1 Products affected

Product hierarchy no. *			Part no.	SBU	Type / Description	Customer part no.
SBU PG	PGU	Type				
90 004	004	0000001008	See list below	Voltage Selector	SWM1	
90 004	010	0000001009	See list below	Voltage Selector	SWM2

2 Type of change

SWM					0118.2287	
creation date	created by	release date	released by	notification no.	revision	page
2015-05-11	helblijo	2015-12-10	schaidro			1 of 3

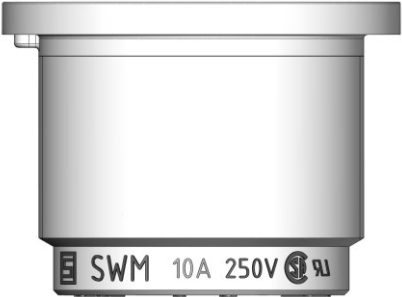
1. Modification of approval marks
2. Material changed on the selector disc

Old marking	New marking
UL	cURus
CSA	
VDE	ENEC10
T85	40T85 ¹
6.3/250V	6.3/250V~
10/250V	10/250V~
Semko	-
SEV	-

¹ 40T85 ~ Allowable Operation Temp. -40°C to 85°C

Old marking	New marking
